Product Change Notification

Change Notification #: 113702 - 00
Change Title: 2U Hot-swap Drive Cage Upgrade Kit 8x3.5
A2U8X35S3HSDK
PCN 113702-00, Product Design
Add peripheral power cable
Date of Publication: March 10, 2015

Figure 1. 500mm peripheral device power cable (G95878-001)

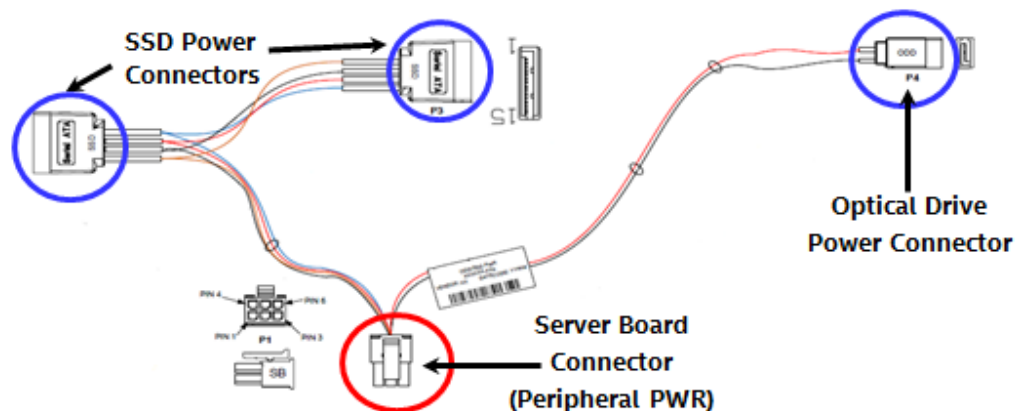
Intel has implemented the following change on the 2U Hot-swap Drive Cage Upgrade Kit A2U8X35S3HSDK:

1. Add one 500mm peripheral device power cable (G95878-001) into the kit.
